User Safety Notice

SCBA Cylinder Quick Connect Adapter

Amended Notice

July 19, 2016

12.3 Installing Quick Connect Adapter to Cylinder

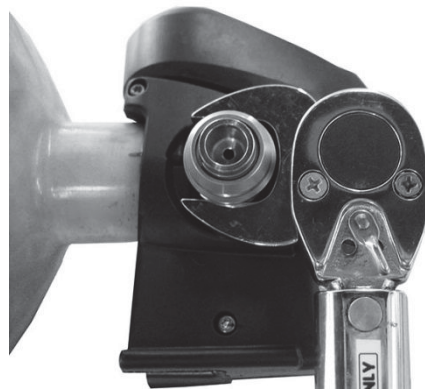
1. Use only a fully charged cylinder and inspect the external threads of the cylinder valve to ensure they are not damaged and free of dirt and debris.
 - The bore of the cylinder valve must be undamaged and free from dirt and debris.
 - If the cylinder valve is damaged, remove from service and return it to a MSA trained or certified repair technician.
2. Inspect the internal threads and nipple of the male adapter to ensure it is not damaged and free of dirt and debris.
 - Ensure that the O-ring is installed on the nipple and free of dirt and debris.
3. Thread the adapter onto the cylinder valve.
 - Securely hold the cylinder assembly and tighten the male adapter to the valve to a torque of 13 - 15 ft-lbs (156 - 180 in-lbs) (18 - 20 Nm) using the torque wrench.

Please note that MSA recently changed the minimum torque requirement in the operating manual from 14 ft-lbs to 13 ft-lbs; however, the maximum allowable torque has remained at 15 ft-lbs since the launch of the quick connect adapter accessory.

NOTE: A calibrated torque wrench with 24 mm open end Crowsfoot is required for installation.
